Job ID: 2012-10-5289-ALTCOMM

has permission for Interior renovations to second floor (Honors Center/ Lounge).

USM Luther Bonney Hall 2nd Floor Renovation

Transmittal

Drawing Title
SECTION THROUGH CORRIDOR
 Drawing Number
SK01

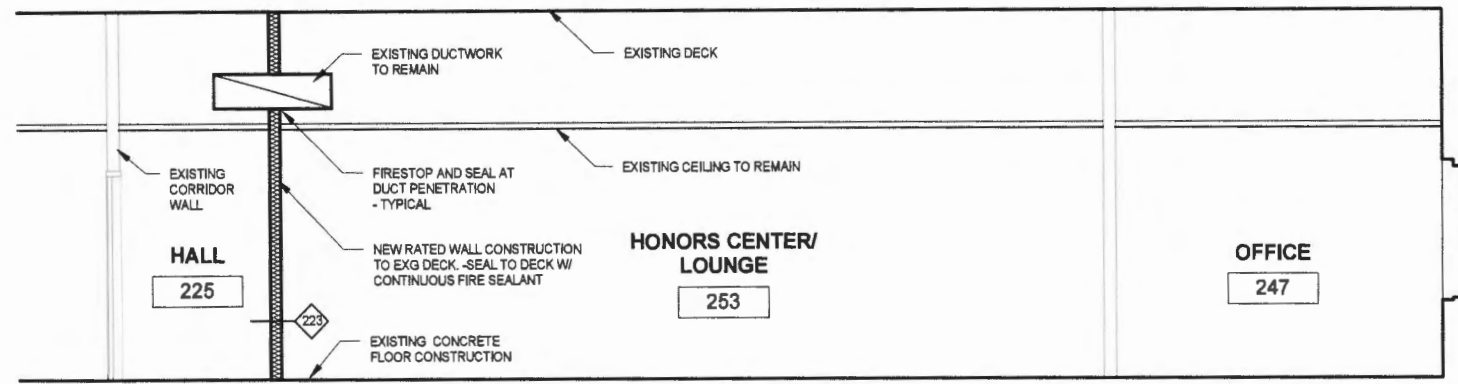
Subject: Section Through Corridor

Remarks: Please find SK01 attached. (Section through Corridor) As requested. I will call to follow up. Let us know if you need any further information.

Drawing Title
**LUTHER BONNEY
 CORRIDOR WALL
 INVENTORY**

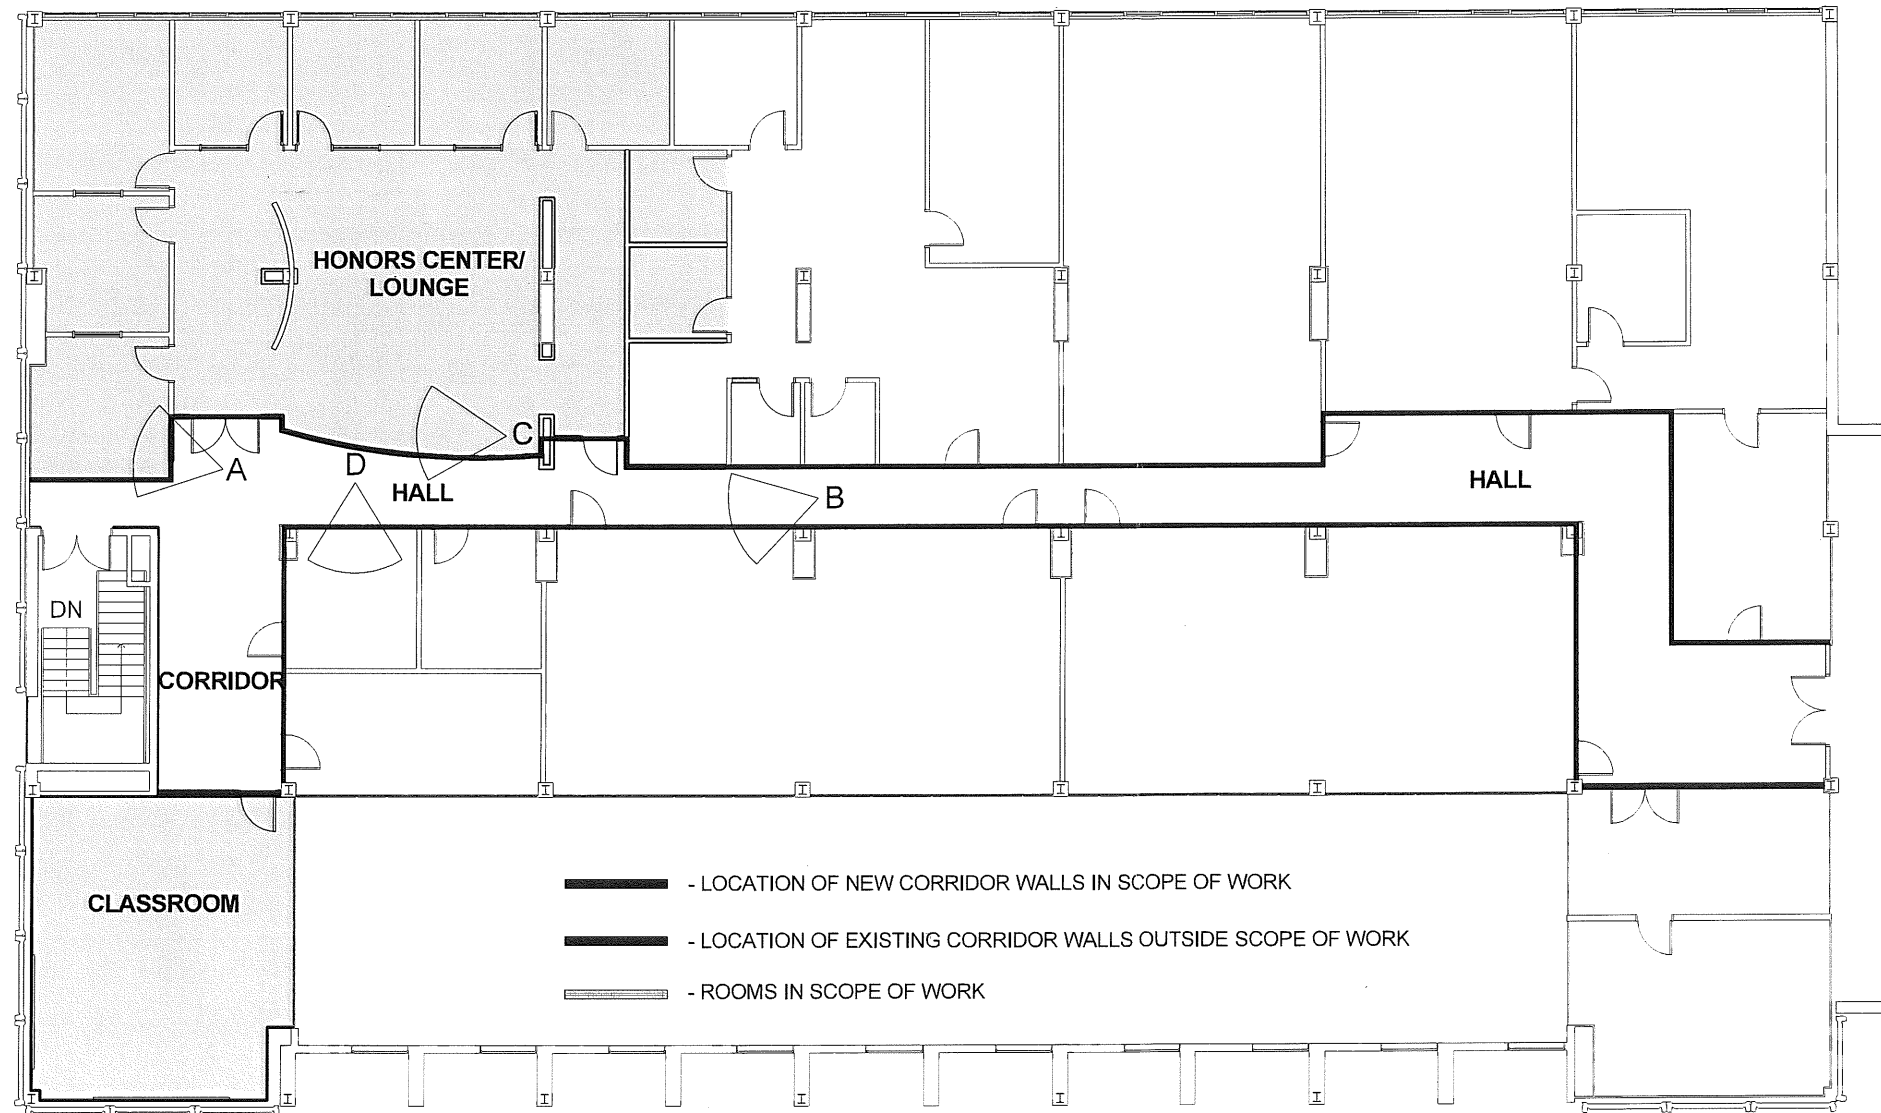
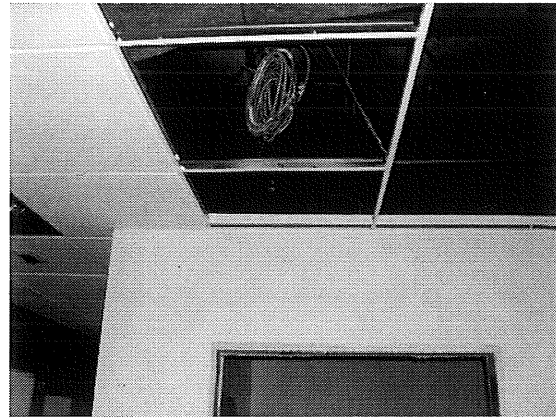
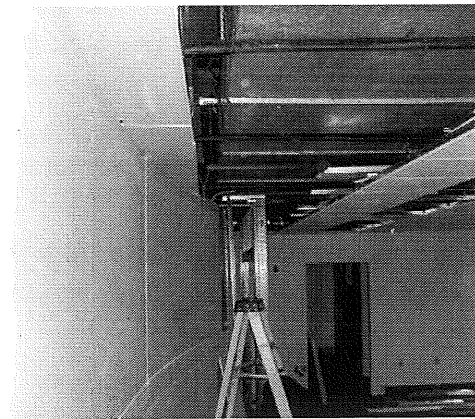
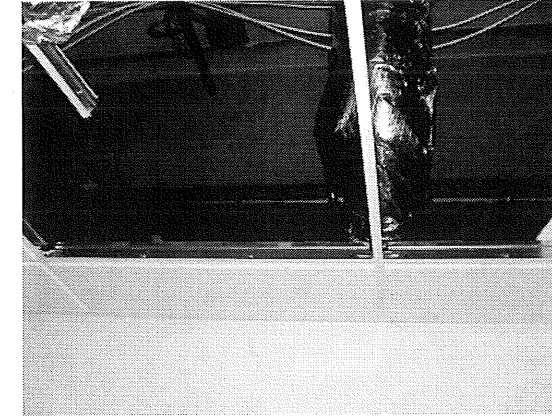
12-5-12 DWM Rob 699-9030 Below grid walls OK.

Provide 1 hr construction to deck above.

Subject: Corridor Wall Continuity
Via: Email
